MARY RIVER – TOTE ROAD ROUND CSP CULVERTS

REQUEST FOR APPROVAL BY DESIGN OFFICE FOR
CHANGE

Date:	April 17, 2024	File No.:	NB102-00181/77-A.01
		Cont. No.:	NB24-00434
To:	Mr. Jim Patterson		
Copy To:	Connor Devereaux, Rudolf Dietrich		
From:	Greg Johnstone		
Re:	CV-216 Design Change due to Massive Ice

Date:	April 18, 2024	File No.:	NB102-00181/93-A.01
		Cont. No.:	NB24-00444
To:	Baruck Wile Rudolf Dietrich		
Copy To:	Dale Tulloch Jim Patterson Sharon Dyke Michael Burns SCP Admin BIM Document Control		
From:	Greg Johnstone		
Re:	Permanent Crossing Plan - Round CSP Culverts, Response to Request for Information (RFI) No. 014

Figure 1 Example of design change shown on Drawing 706 R2 CV-114

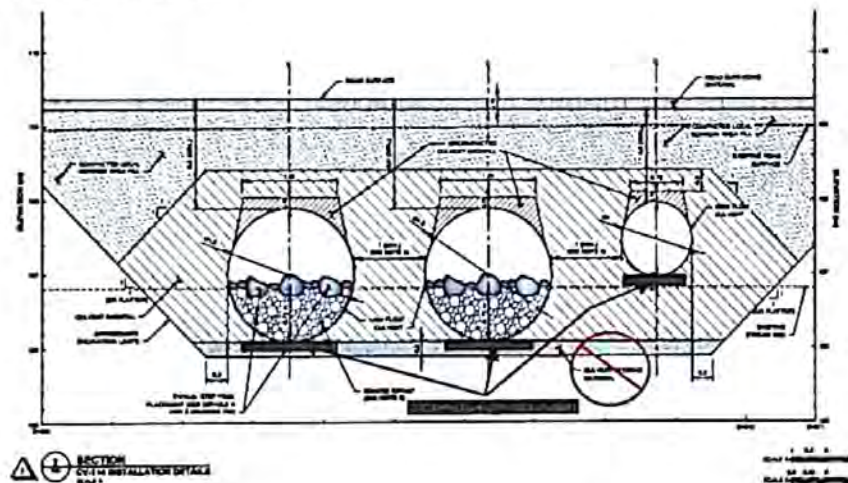
The purpose of the design change is to change part of the 25 mm minus bedding material (Fine Culvert Backfill) to a finer 3/16 inch minus material to meet the culvert manufacturer's recommendations. The design change will result in a 50 mm (2 inch) minimum thick, ½ culvert diameter wide, uncompacted zone of 3/16 inch minus crushed material being placed under the culvert(s) in place of the 25 mm minus material (See Figure 1). This design change will apply to all 10 round CSP culvert installations.

This change was requested by KP following receipt of recommendations from the culvert manufacturer (Armtec) to use a smaller size material that will fit between the round CSP culvert corrugations.

CV-216 PROPOSED DESIGN CHANGE

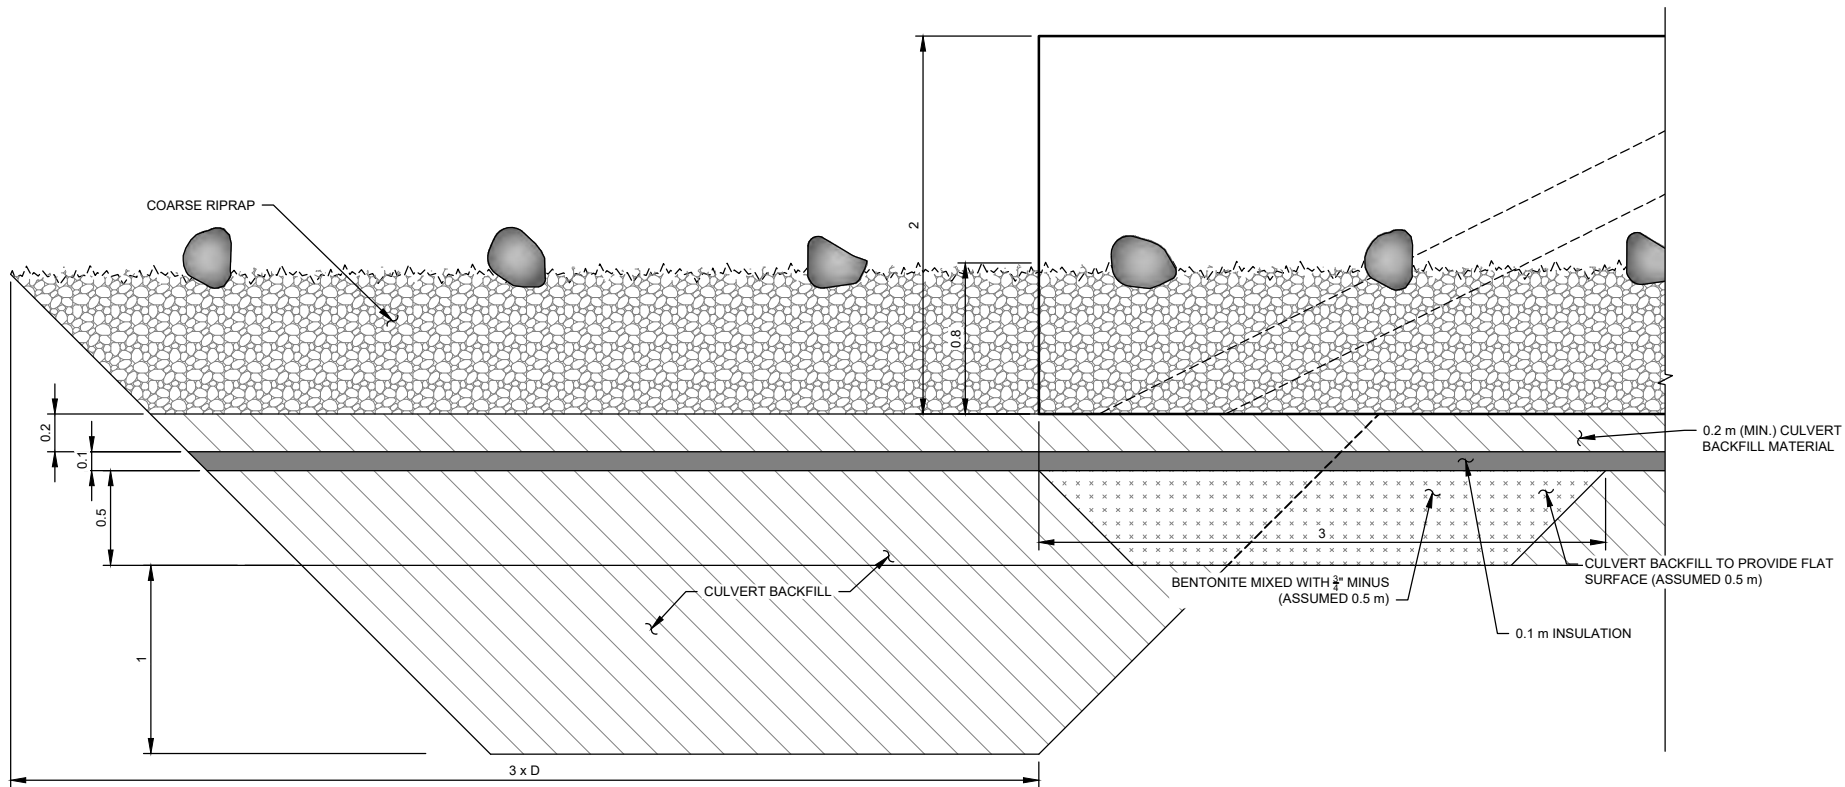
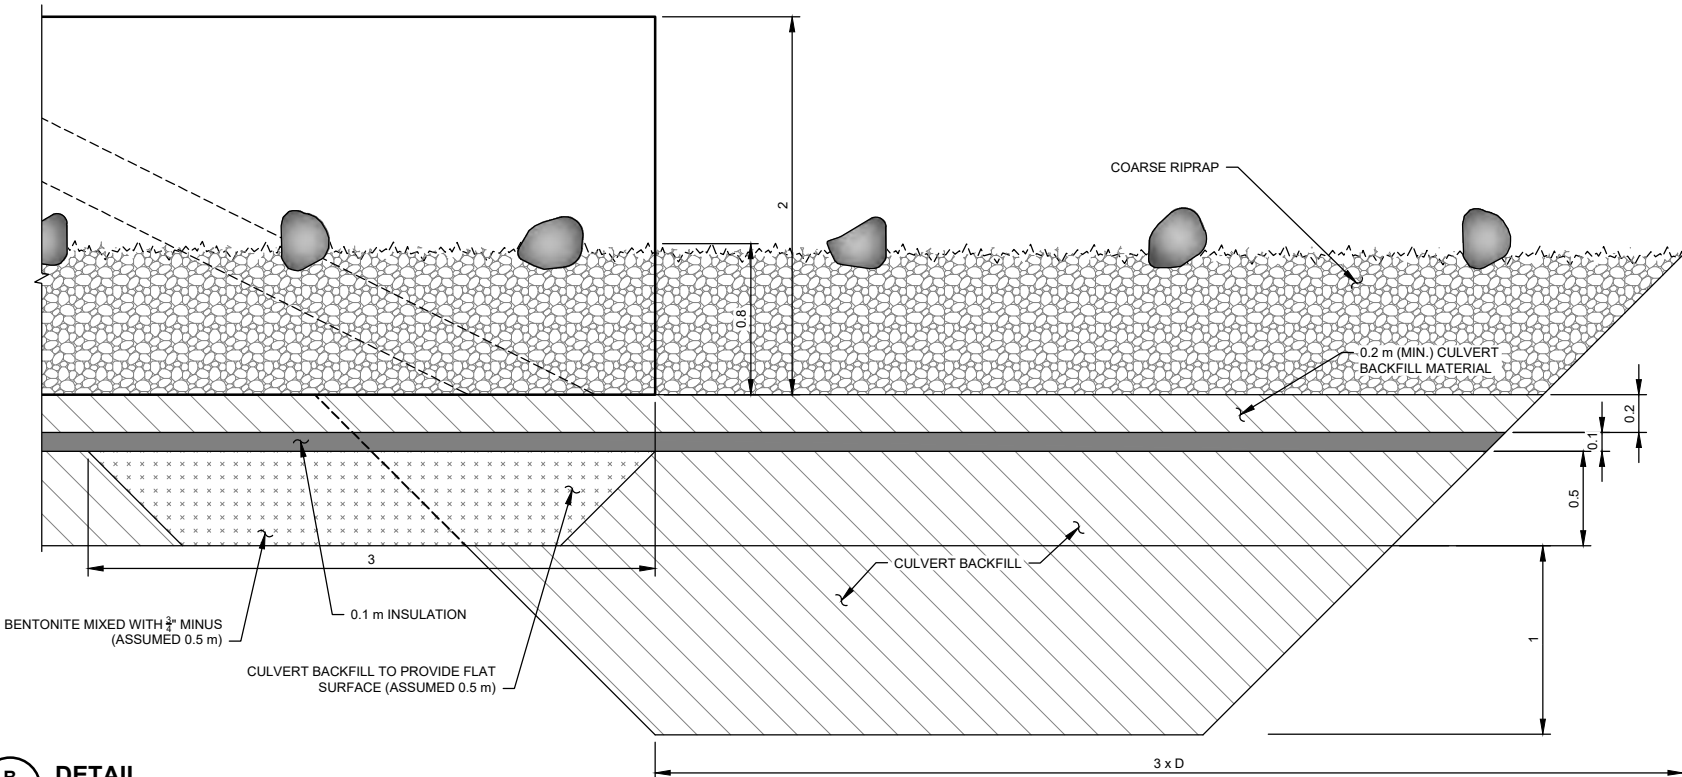
The proposed design change for CV-216 consists of over-excavation of the massive ice below the culvert and the installation of fill and insulation to minimize the impacts of ambient temperatures and heat laden water flows on the ice beneath the culvert foundation (i.e. minimize potential for thawing).

The culvert foundation construction will include installation of an insulation layer above a 0.5 m thick layer of compacted non-frost susceptible culvert backfill material. The insulation will consist of two layers of 2 inch (50 mm) thick Styrofoam™ Highload 60 Extruded Polystyrene, or approved equivalent. Joints in the insulation sheets will be offset to prevent gaps in the coverage and enhance effectiveness. Following the insulation installation, a 0.2 m thick layer of compacted culvert backfill will be placed over the insulation as the base course for culvert installation.

The inlet and outlet of the culvert will be over-excavated and backfilled with compacted non-frost susceptible culvert backfill material. Bentonite will be mixed with $\frac{3}{4}$ inch minus material for the initial and final 3 m of the culvert length to act as an impermeable layer to minimize the potential for water to migrate beneath the culvert/insulation and transmit heat into the underlying ice.

The CV-216 inlet and outlet areas will be constructed similar to locations CV-102 and CV-106 as shown on Drawing 781 Detail D provided with the original design report (KP, 2024). The proposed design change is shown on the attached Figure 1 and the inlet and outlet apron detail is shown on Figure 2.

Figure 1 CV-216 Geomembrane Key-In Trench Design Change

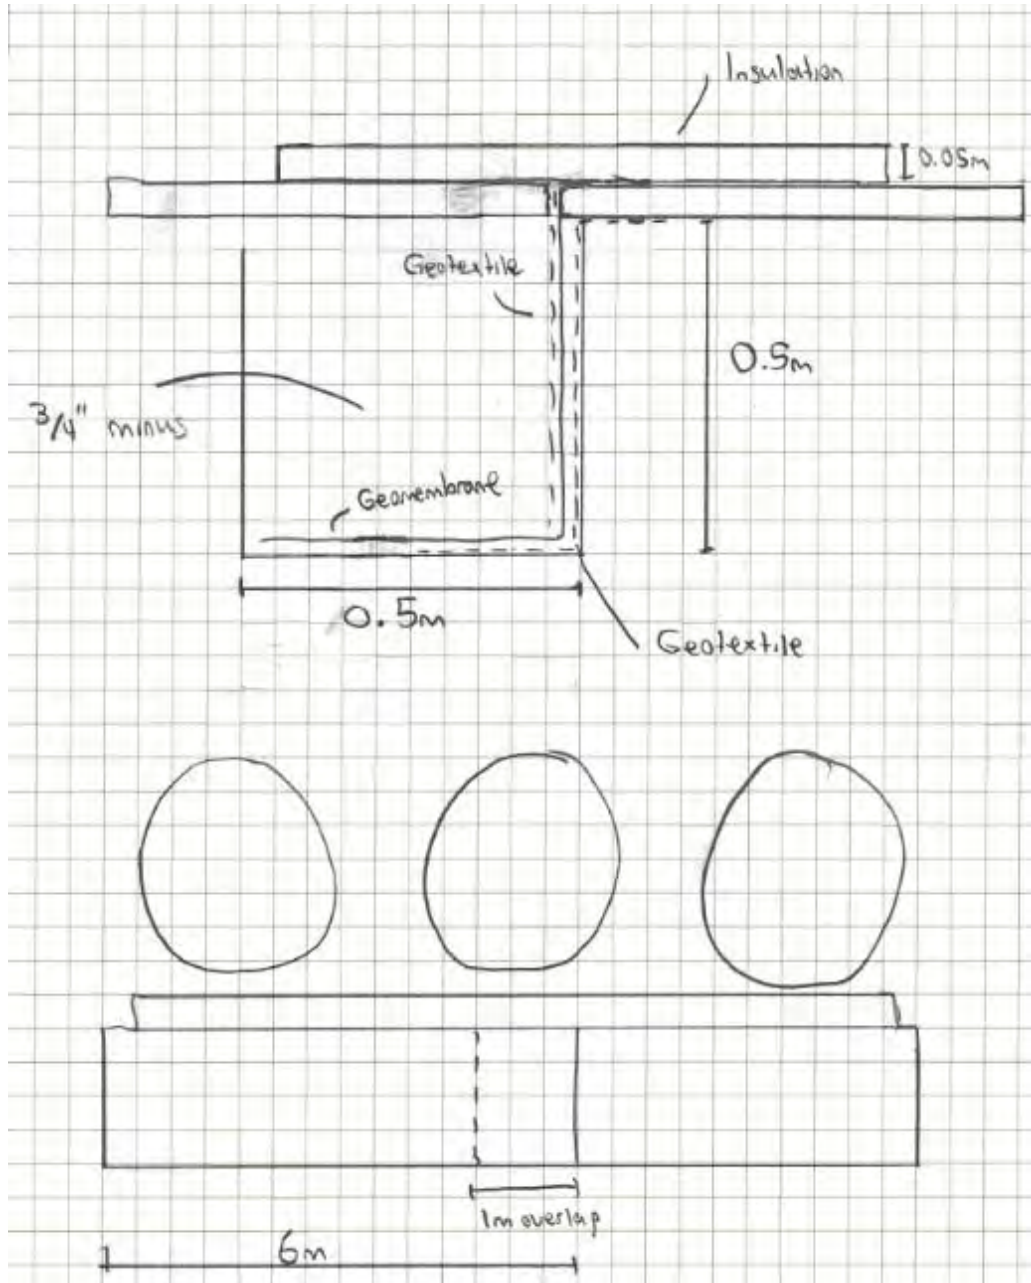
A large ice mass has been encountered in the foundation of culvert CV216 (see photo below). The ice mass in this location has prompted a potential design change by the Engineer for this culvert.

Nuna requests the revised CV216 design to be provide through Document Control bimdc@nunagroup.com as soon as possible as the construction of this culvert is currently underway.

KP provided a memorandum and figure to Baffinland on April 17 describing the design change details for the foundation at CV-216 (attached). Following the issuance of this memorandum Baruck Wile from Baffinland informed KP that there are not sufficient quantities of bentonite to construct the foundation per the design change. As such, KP has revised the design change to incorporate geomembrane with a key in trench in place of bentonite mixed with $\frac{3}{4}$ " minus material. The proposed geomembrane key-in trench is shown on Figure 1. The key in trench is to be backfilled with compacted $\frac{3}{4}$ " minus material.

CV-216 PROPOSED DESIGN CHANGE

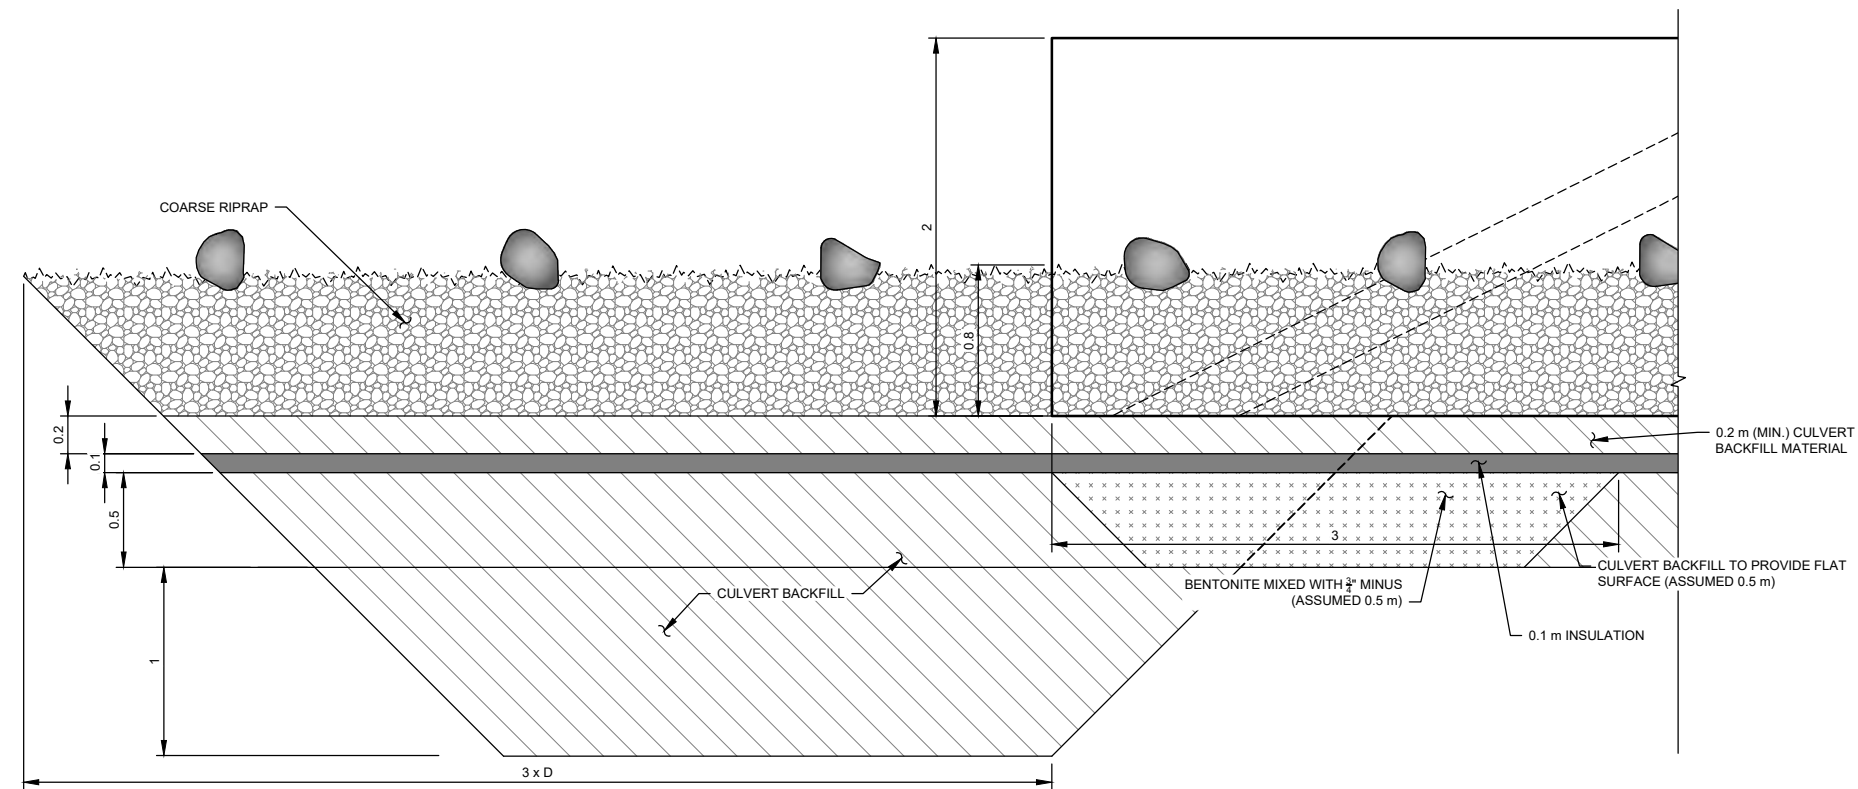
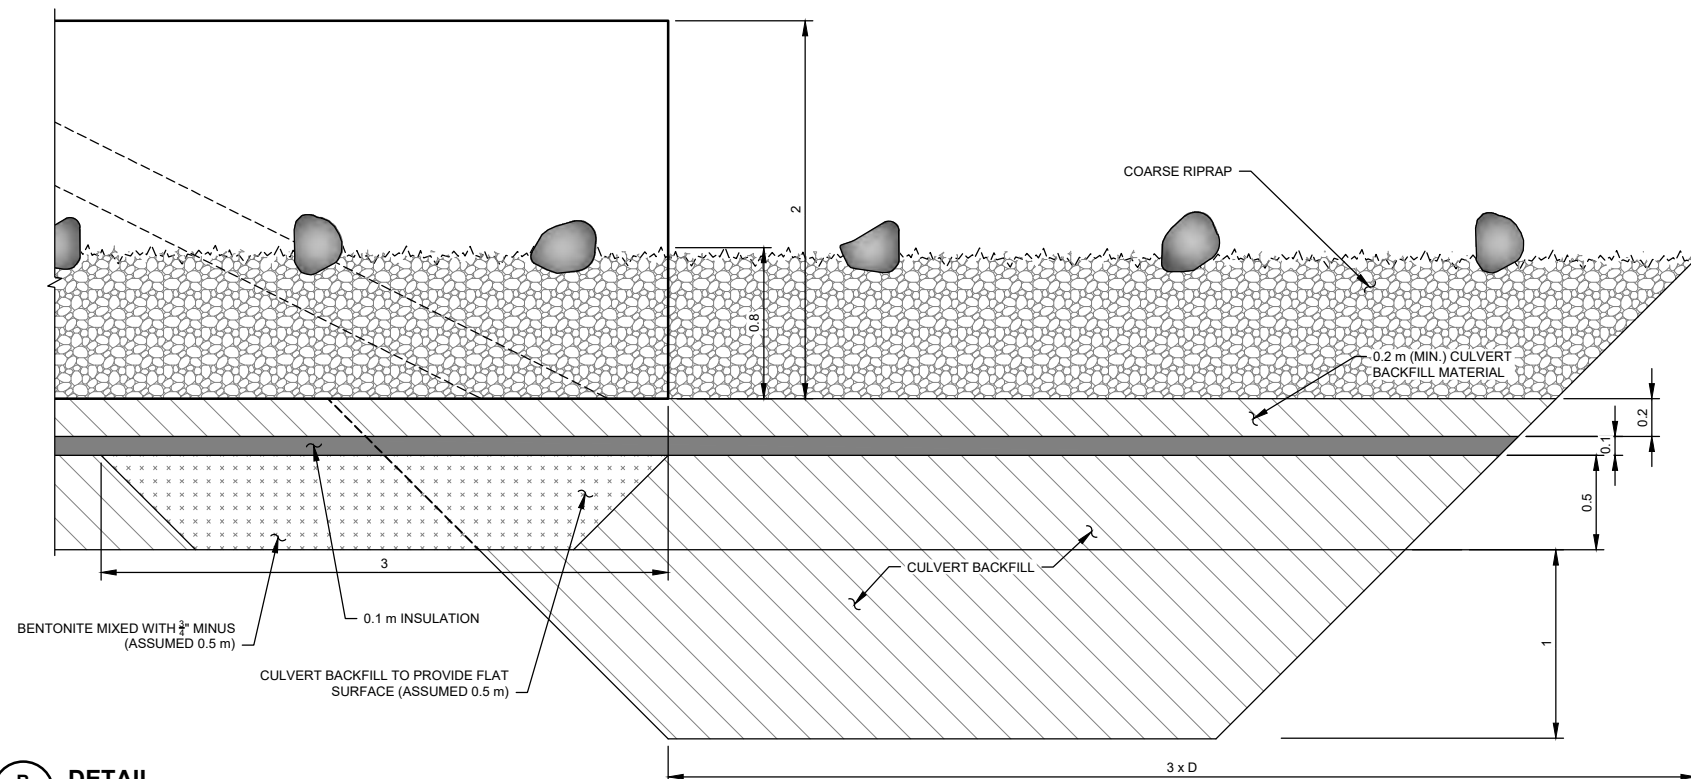
The proposed design change for CV-216 consists of over-excavation of the massive ice below the culvert and the installation of fill and insulation to minimize the impacts of ambient temperatures and heat laden water flows on the ice beneath the culvert foundation (i.e. minimize potential for thawing).

The culvert foundation construction will include installation of an insulation layer above a 0.5 m thick layer of compacted non-frost susceptible culvert backfill material. The insulation will consist of two layers of 2 inch (50 mm) thick Styrofoam™ Highload 60 Extruded Polystyrene, or approved equivalent. Joints in the insulation sheets will be offset to prevent gaps in the coverage and enhance effectiveness. Following the insulation installation, a 0.2 m thick layer of compacted culvert backfill will be placed over the insulation as the base course for culvert installation.

The inlet and outlet of the culvert will be over-excavated and backfilled with compacted non-frost susceptible culvert backfill material. Bentonite will be mixed with $\frac{3}{4}$ inch minus material for the initial and final 3 m of the culvert length to act as an impermeable layer to minimize the potential for water to migrate beneath the culvert/insulation and transmit heat into the underlying ice.

The CV-216 inlet and outlet areas will be constructed similar to locations CV-102 and CV-106 as shown on Drawing 781 Detail D provided with the original design report (KP, 2024). The proposed design change is shown on the attached Figure 1 and the inlet and outlet apron detail is shown on Figure 2.

Figure 1 Approximate area of placed Culvert Infill Material containing snow at BG-04 Culvert shown in red (From Drawing 745 R2)

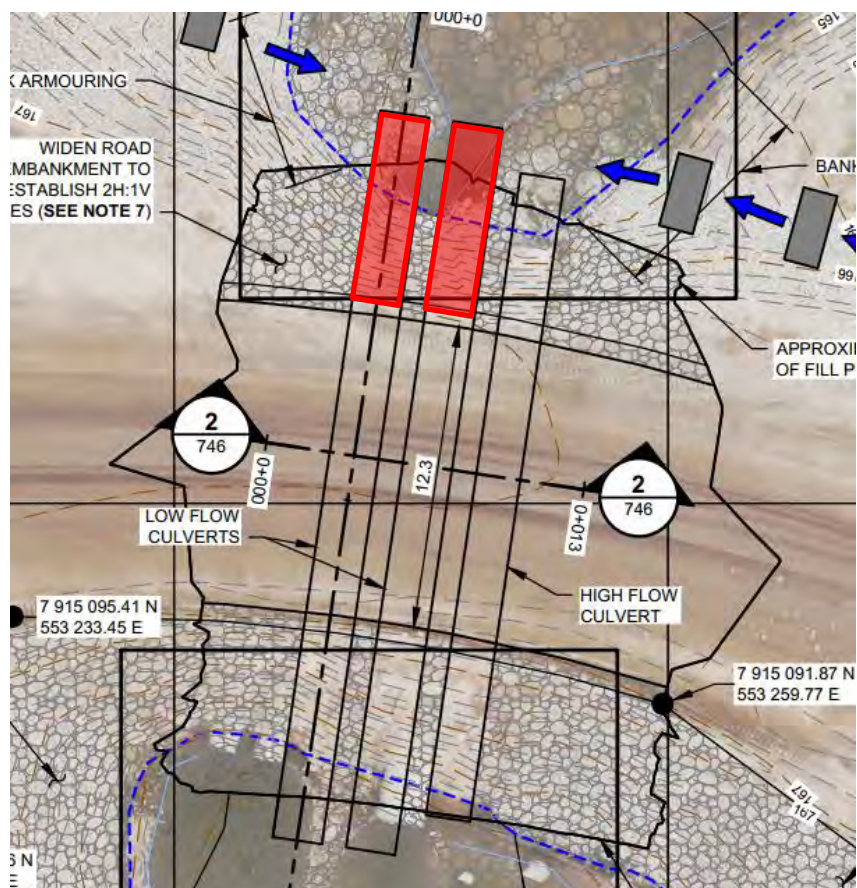
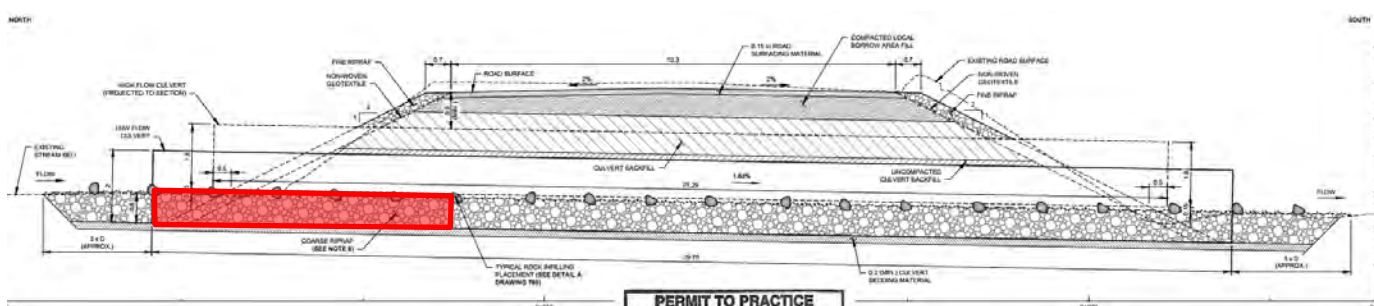
During the beginning of nightshift of April 2, 2024, it was observed that the Culvert Infill Material being placed by Nuna to backfill the inside of the two (2) low flow culverts at BG-04, for the first 8 m of fill on the inlet ends contained entrained snow (See Figure 1 and Figure 2). The Stream Substrate Material being used to mix with the Coarse Riprap, as well as the Coarse Riprap was observed to have snow mixed into the stockpiles which were then used for the culvert infilling.

The Culvert Infill Material within the identified area of the two (2) low flow culverts at BG-04 therefore did not meet the technical specifications identified in Note 3 in the Permanent Crossing Plan Culvert Fill Materials and Geosynthetics Specifications Drawing No. 703, Rev 3.

Removal of the placed Culvert Infill Material is the preferred option; however, this is recognized as being very difficult to complete due to the size of the material and difficulty using mechanization. In lieu of removing the material, additional natural stream substrate material should be placed on the surface of the 8 m section of each infilled culvert. It is recommended that this material consist of an approximately 10 cm thick lift of Stream Substrate Material only (no riprap). The expectation is that this additional material will assist in filling any voids that might be caused by the melting of the snow mixed with the Culvert Infill Material.

For the remaining length of the culvert infilling (and all future infilling), natural stream substrate material not containing snow or ice must be used. KP will complete control tests to document that the Stream Substrate Material is viable and does not contain significant quantities of snow.
